**DWR PERRIS DAM
EMERGENCY RELEASE FACILITY**

**Addendum No. 2
SCH No. 2013091027**

**Prepared for
Department of Water Resources**

December 2022

Figure 2
Proposed Modification

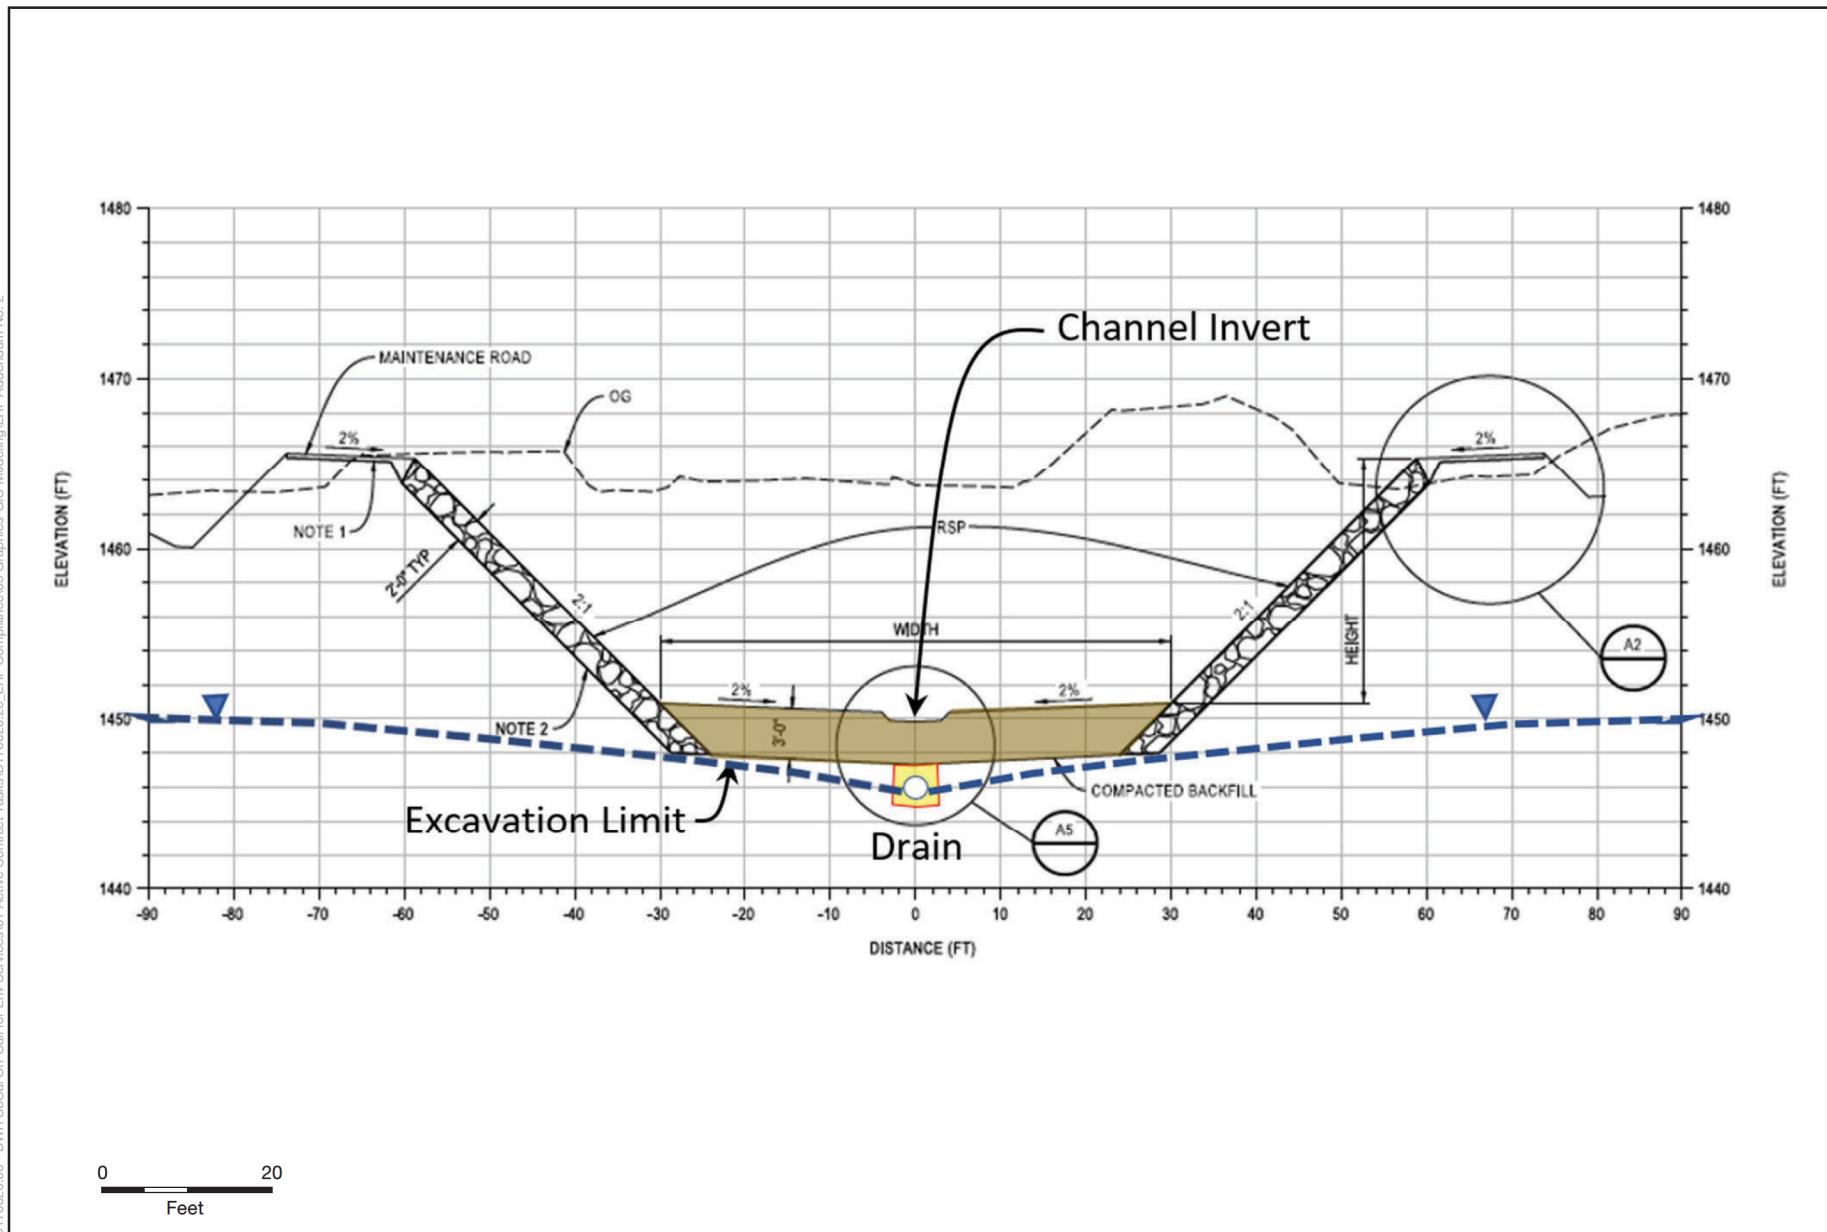
The proposed modifications to the Project evaluated in this Addendum include minor modifications to existing Project components. The proposed modifications include the implementation of a groundwater collection system, referred herein as the “channel underdrain,” along the proposed channel and the addition of a coated wire mesh to the levee slopes. In addition, mitigation measure TRANS-1 has been modified and DWR is transferring a parcel to the 46th District Agricultural Association (46th District).

underdrain to be constructed under the centerline of the channel, along the entire channel length (Figure 2). This would constitute a minor design change that would not increase the footprint or capacity of the channel. The purpose of the underdrain would be to prevent groundwater from pooling within the new channel.

Figure 3
Proposed Channel Underdrain Conceptual Design

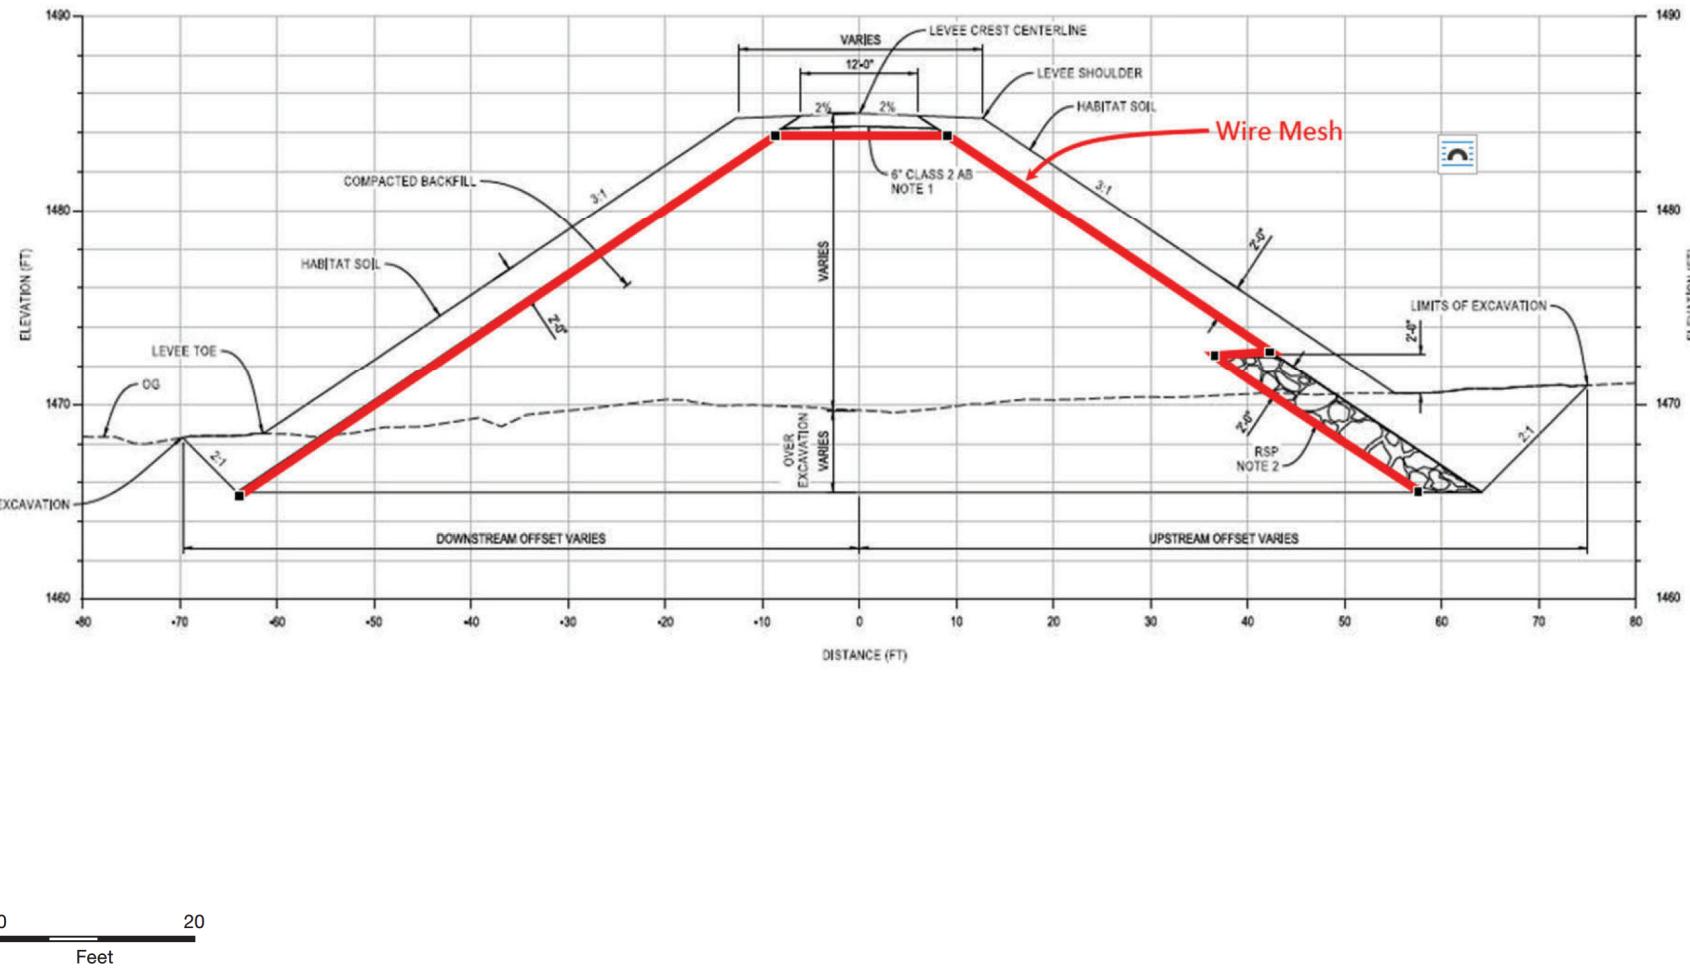
The proposed underdrain pipe would be a slotted, 12-inch diameter PVC pipe. The underdrain pipe would be surrounded by crushed rock wrapped in filter fabric. The slotting, crushed rock, and filter fabric would allow groundwater to enter the channel underdrain in locations of high groundwater while simultaneously allowing collected water to flow out of the pipe in locations where the groundwater table is lower. The channel underdrain would be underground for the entire length of the channel except where it connects to the Perris Valley Channel (**Figure 3**). It is anticipated that the majority of collected groundwater would infiltrate back into the ground before it reaches the Perris Valley Channel. In the event that not all the water infiltrates back into the ground, the channel underdrain would terminate at a concrete wingwall in the Perris Valley Channel and would be protected by a flap gate. The flap gate would allow any excess water which has not infiltrated back into the ground to drain into the Perris Valley Channel and also prevent flows within the Perris Valley Channel from entering the channel underdrain. Cleanout locations would be added along the proposed channel to facilitate future maintenance of the channel underdrain.

The channel underdrain pipe would be installed in 20-foot-long sections. A trench would be excavated along the center of the channel. The channel underdrain pipe would be placed along with rock and filter fabric in the trench. The pipe depth would vary, but the centerline of the pipe would be between 1.5 and 4 feet below the channel bottom. Construction of the channel underdrain would require three construction workers daily.
